SPORTS ARENA

SERVICE BULLETIN

NEW TILT KIT (Plum Bob Style) Available !

FRONT INSIDE VIEW OF CABINET

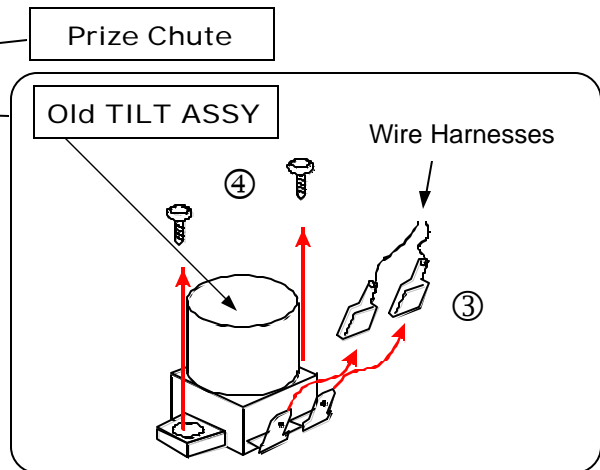
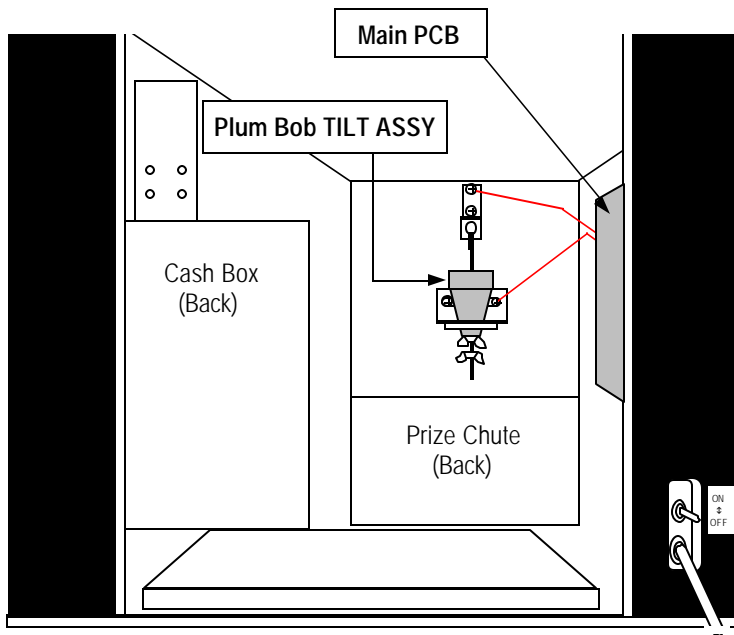
1) Remove the Old TILT ASSY from Cabinet. Refer to picture below:

- 1 Open the Coin Door.
- 2 Old TILT ASSY is mounted on top of Prize Chute.
- 3 Take off 2 Wire Harnesses from Old TILT ASSY. (Wire colors are BLK and WHT)
- 4 Take off the 2 of screws to remove the Old TILT ASSY from cabinet.

BACK BOTTOM INSIDE VIEW OF CABINET

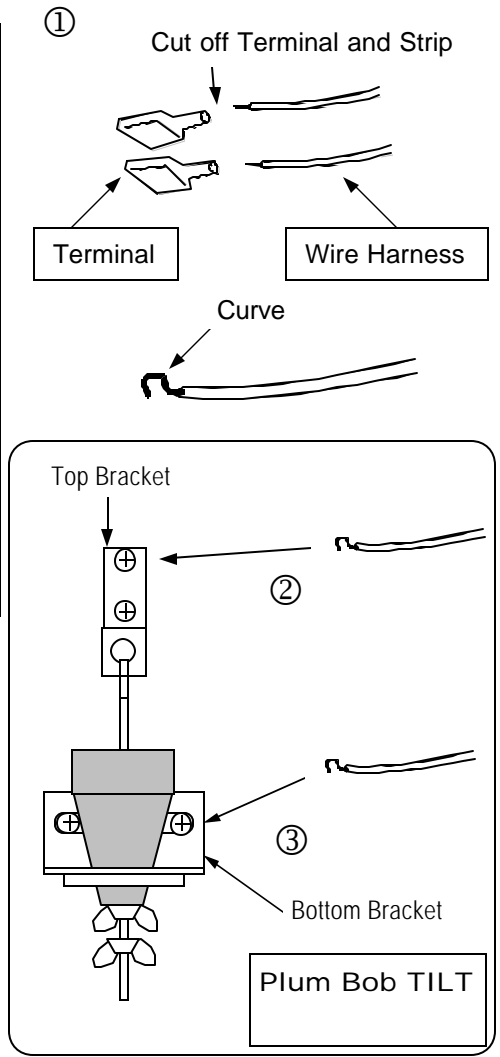
- 2) Open Bottom Back Door of cabinet. Mount NEW Plum Bob TILT ASSY to Back of Prize Chute. Refer to picture below:

- 1 Cut off the terminal of Original TILT Wires and strip about 1/4".
- 2 Tighten either wire around top screw on Top Bracket. (Wire color does not matter.)
- 3 Tighten other wire around bottom screw on Bottom Bracket. (Wire color does not matter.)

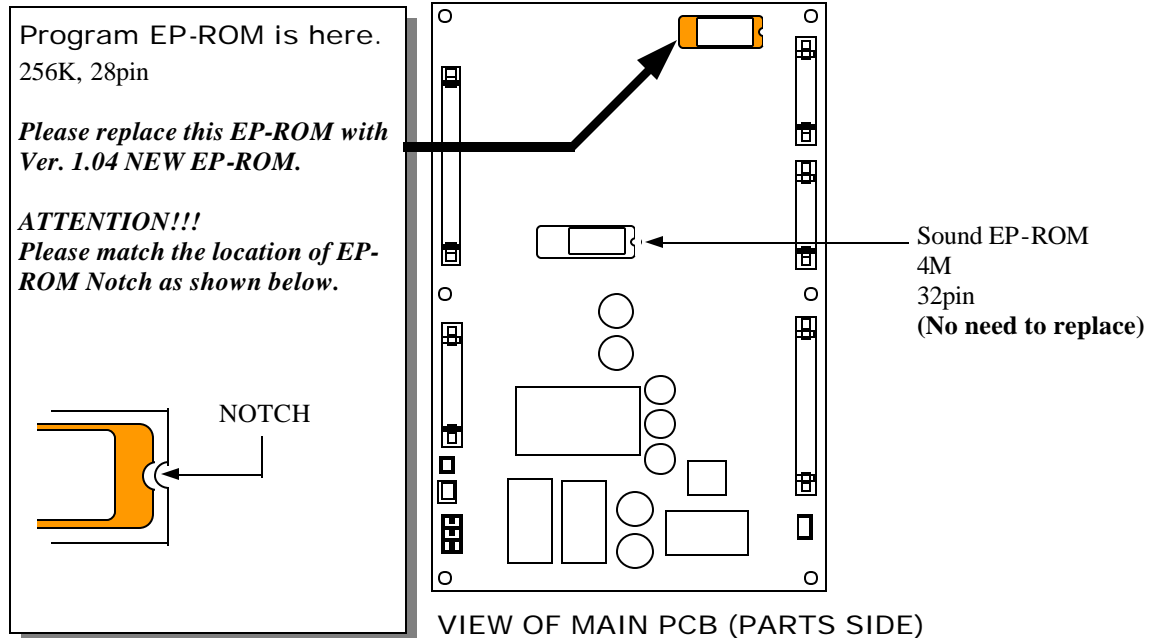
3) Exchange Program EP-ROM to Ver. 1.04. (Refer to next page.)

- 1 Main PCB is mounted on Right side of cabinet.
- 2 Remove Old EP-ROM (Ver. 1.01 to 1.03) and mount NEW EP-ROM Ver. 1.04.
